RESPONSE TO REQUEST FOR ADDITIONAL INFORMATION

APR1400 Design Certification

RAI No.: 43-7887

Question No. 07.01-25

Figure 1 SYSL PC Element

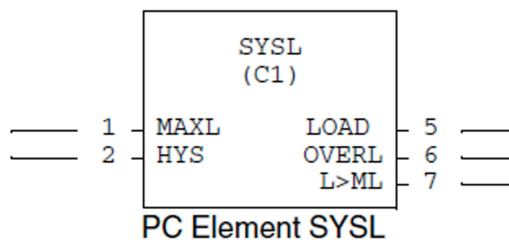
Provide adequate design information and accompanying analysis to demonstrate predictable and repeatable operation of the CPCS central processing unit (CPU) when processor loading exceeds 70 percent. Provide the basis and analysis for the 70 percent CPU loading criteria and describe how the particular tests and analyses proposed in the application will be conducted to verify predictable and repeatable behavior. Include an inspection, tests, analyses, and acceptance criteria (ITAAC) item to include the necessary analysis and test to ensure predictable and repeatable operation of the CPCS system once software development has been completed and for support of future software maintenance.

Technical Report APR1400-A-J-NR-14004-P, Rev. 0, "Common Q Platform Supplemental Information in Support of the APR1400 Design Certification," states, in part, that the maximum load of the Common Q platform CPU (AC160) to be used for the APR1400 CPCS system needs to be raised to 75 percent, which exceeds the 70 percent CPU load limit as specified in the Common Q Topical Report, WCAP- 16097-P-A, Rev. 3. In addition, many restrictions for configuration and programming have been proposed in the above technical

report APR1400-A-J-NR-14004-P, so the task processing and communication in the CPCS could be deterministic. Particular tests are proposed to be conducted to ensure that the CPCS system will behave in a predictable and repeatable manner. However, the above Common Q Topical Report specifies that the maximum CPU load must not exceed a value of 70 percent to ensure the deterministic communication. Describe how the CPCS system will be able to reliably perform all scheduled CPU tasks when the CPU load exceeds 70 percent. The description should include the basis for the CPU loading criteria, analysis, and/or outline the analysis to be performed that demonstrates reliable performance for CPU loading once the software is completed. Also, describe how the proposed tests will be conducted to verify the deterministic communication and include an ITAAC to ensure that the necessary analysis and tests will be conducted to ensure the CPCS CPU tasks behave in a predictable and repeatable manner.

The load on a CPCS processor module will be verified to not exceed 75%. This is done via the PC Element SYSL. SYSL was qualified for use as part of the original AC160 software. SYSL allows the user to monitor the load on the system. Figure 1 describes the SYSL PC Element. Further information on the SYSL usage is described in the PC Element Reference Manual (Reference 6).
